SERVICE BULLETIN SB00.25

Machines/Models: LX31/41/50 4WD **Serial Numbers:** 3305 -4022

PURPOSE: Enhance Axle Lock Cylinder Durability

PROCEDURE REQUIRED: Replace the Axle Float Cylinder

Figure 2 (After)

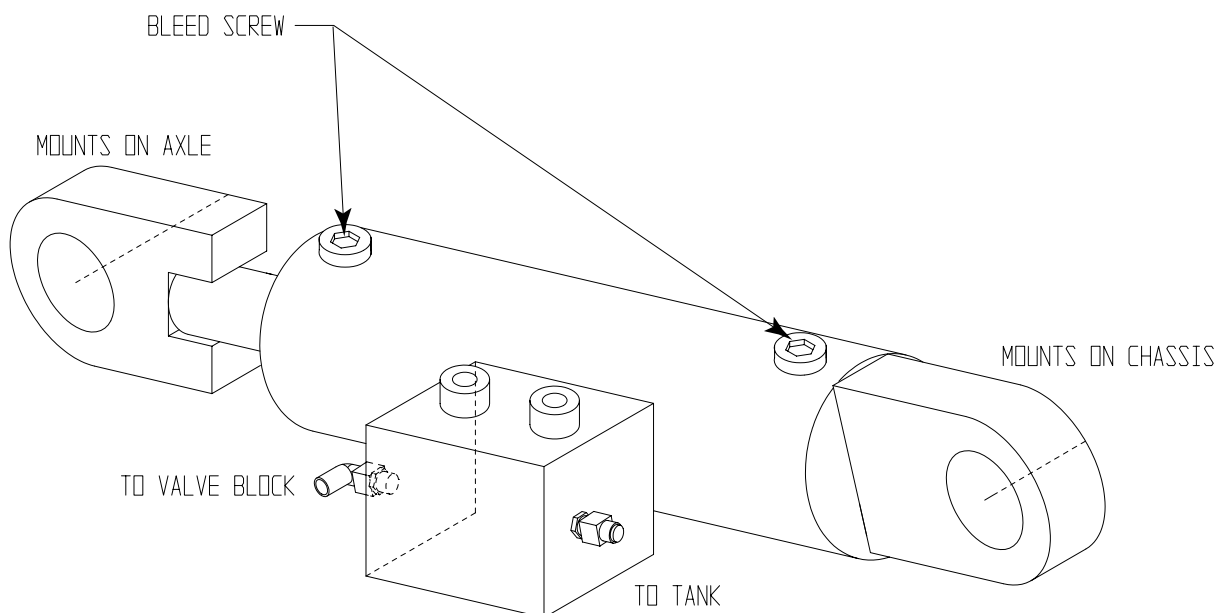
Note: The supplied cylinder is to be installed with the rod end attached to the axle and the cylinder end attached to the chassis.

6. Position into place the supplied axle float cylinder and insert the attachment pins see Figure 2 and 3.
7. Torque the attachment pin nuts to 700 ft lbs (950 Nm).
8. Reconnect the hydraulic lines to the cylinder ports see Figure 3.
9. With the platform lowered drive the machine's right front tire onto a 6-7" block.
10. Leave engine running and bleed both bleed screws one at a time. Tighten bleed screws and check for leaks see Figure 3.
11. Drive the machine off of the block and elevate the machine 24" until the front axle locks.
12. Drive the right front tire of the machine back onto the 6-7" block and verify the axle float cylinder does not move in excess of 1/16".
13. Drive the left front tire of the machine onto the 6-7" block and verify the axle float cylinder does not move in excess of 1/16".
14. If measurement in step 11 or 12 is in excess of a 1/16" repeat steps 9 through 13.
